UNITED STATES PATENT AND TRADEMARK OFFICE

APPLICATION NO.	FILING DATE	FIRST NAMED INVENTOR	ATTORNEY DOCKET NO.	CONFIRMATION NO.
10/665,040	09/18/2003	Warren Lin	26571-502	4471

Office Action Summary

DETAILED ACTION

Fig-1

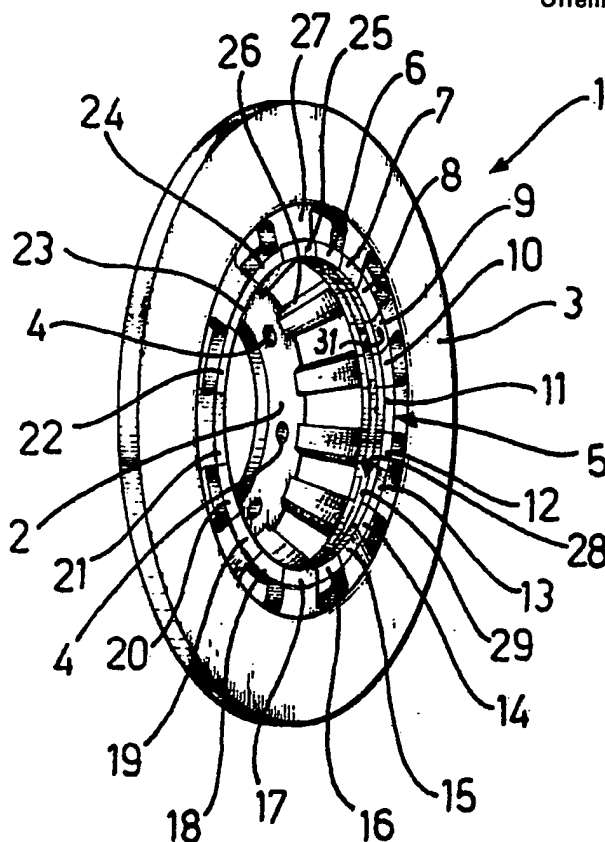
Re: claims 1, 22, and 26. DE'108 shows in figure 1 a brake rotor 3 comprising a central mounting portion 2 for mounting the brake rotor on a hub, a first annular braking surface and a second annular braking surface, wherein each braking surface includes an inner diameter and an outer diameter, a bridge 27,29 provided between the central mounting portion and the inner diameter of at least one of the first and the annular braking surfaces, and a plurality of ribs 26 positioned proximate to the bridge.

DE'108 includes the limitation wherein the central mounting portion, the braking surfaces, the bridge, and the ribs are formed in a single piece under assembly via the element 29 as shown in figure 1.

Re: claim 3. DE'108 shows in figure 1 the limitation wherein the bridge includes a plurality of openings or spaces enclosed by elements 27 and element 29.

Re: claim 8. DE'108 shows in figure 1 the limitation of the rotor further comprising a hat portion or inner cylindrical wall of element 2 disposed in the central portion and adapted for mounting the rotor to a vehicle.

Re: claims 1 and 4. In an alternate interpretation, DE'108 shows in figure 1 a brake rotor 3 comprising a central mounting portion 2 for mounting the brake rotor on a hub, a first annular braking surface and a second annular braking surface, wherein each braking surface includes an inner diameter and an outer diameter, a bridge 26,29 provided between the central mounting portion and the inner diameter of at least one of the first and the annular braking surfaces, and a plurality of ribs 27 positioned proximate to the bridge.

DE'108 includes the limitation wherein the central mounting portion, the braking surfaces, the bridge, and the ribs are formed in a single piece under assembly via the element 29 as shown in figure 1.

Fig-2

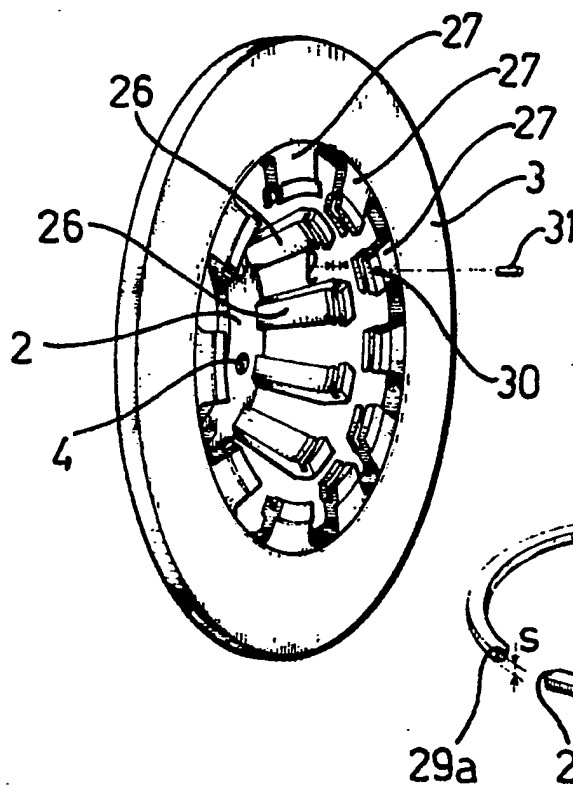
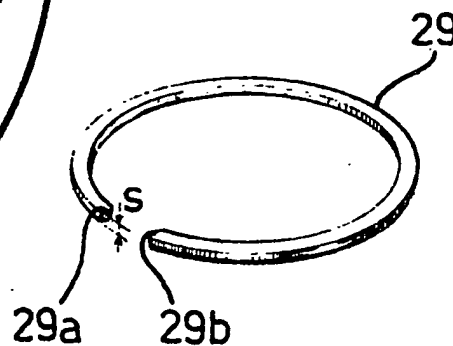
Re: claims 1, 22, and 26. Russell et al. show in figure 2 a brake rotor shown in the area of element 5 comprising a central mounting portion or mounting bore in top element 9 for mounting the brake rotor on a hub 1, a first annular braking surface to the left of the lead line of number 3 and a second annular braking surface 5, wherein each braking surface includes an inner diameter and an outer diameter, a bridge or solid portion of top element 9 provided between the central mounting portion and the inner

Re: claim 2. Russell et al. show in figure 2 the limitation wherein the bridge 9 is substantially solid and wherein at least a portion of at least one rib (remaining elements 9) protrudes above a surface (particularly a bottom surface) of the bridge.

Re: claim 5. Russell et al. show in figure 2 the limitation wherein at least one of the plurality of ribs are integral to a side of a flow channel shown between elements 7 of a vented brake rotor.

Re: claims 1, 22, and 26. In an alternate interpretation of the Russell et al. reference, Russell et al. show in figure 2 a brake rotor shown in the area of element 5 comprising a central mounting portion or element 1 for mounting the brake rotor on a hub shown immediately to the left of the lead arrow of number 15, a first annular braking surface to the left of the lead line of number 3 and a second annular braking surface 5, wherein each braking surface includes an inner diameter and an outer diameter, a bridge or all elements 9 provided between the central mounting portion and the inner diameter of at least one of the first and the annular braking surfaces, and a plurality of ribs 7 positioned proximate to the bridge.

Re: claims 3 and 18. Russell et al. show in figure 2 the limitation wherein the rotor comprises a plurality of openings positioned in the bridge or the apertures shown in each of elements 9.

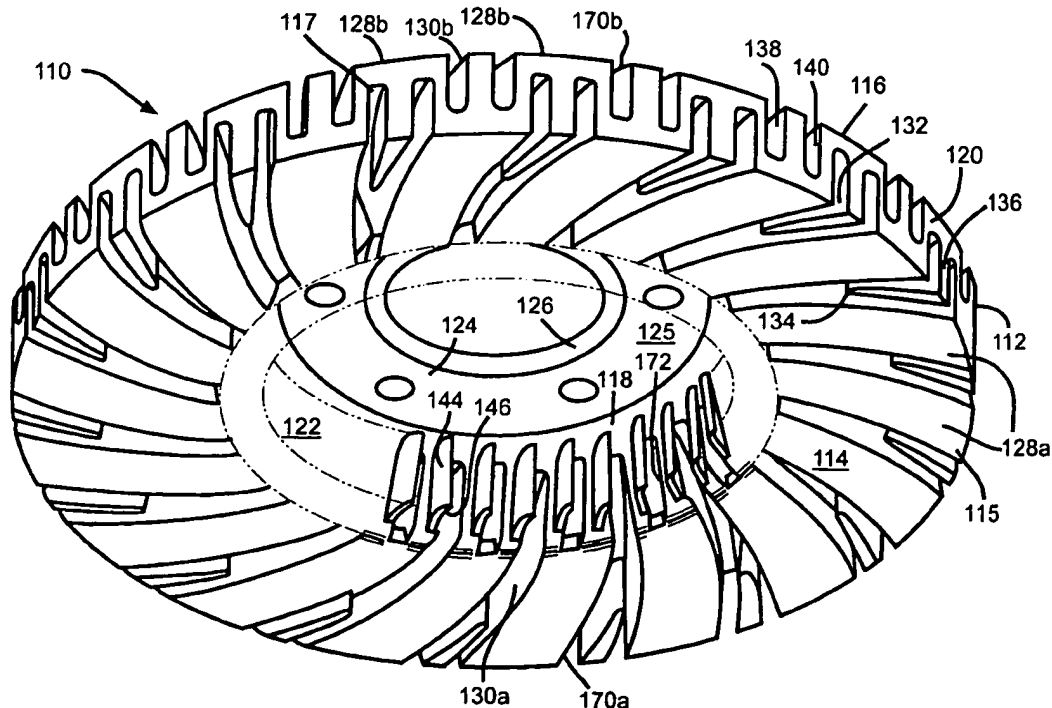
Re: claims 1, 2. Garfinkel et al. show in figure 6 a brake rotor 110 comprising a central mounting portion 124 for mounting the brake rotor on a hub, a first annular braking surface and a second annular braking surface, wherein each braking surface includes an inner diameter and an outer diameter, a bridge 122 provided between the central mounting portion and the inner diameter of at least one of the first and the annular braking surfaces, and a plurality of ribs 144 positioned proximate to the bridge.

Re: claim 5. Garfinkel et al. show in figure 6 the limitation wherein at least one of the plurality of ribs 144 is integral to a side of a flow channel 130a of a brake rotor.

Re: claim 6. Garfinkel et al. show in figure 6 the limitation wherein either or both of the annular braking surfaces includes one or more slots 117.

Re: claim 7. Garfinkel et al. show in figure 6 the limitation of the rotor further comprising one or more pairs of openings (the opening within the bridge 122, the opening in the area of element number 126 and the pairs of openings shown at 138 and 140, for example, each pair of opening allowing communication between the first annular braking surface and the second annular braking surface.

Re: claim 8. Garfinkel et al. show in figure 6 the limitation of the rotor further comprising a hat portion shown in the area of element 126 disposed in the central portion and adapted for mounting the rotor to a vehicle.

Re: claim 9. Garfinkel et al. show in figure 6 the limitation wherein a first opening or hole within element 122 allows the first annular braking surface to fluid communicate with a vent 130a.
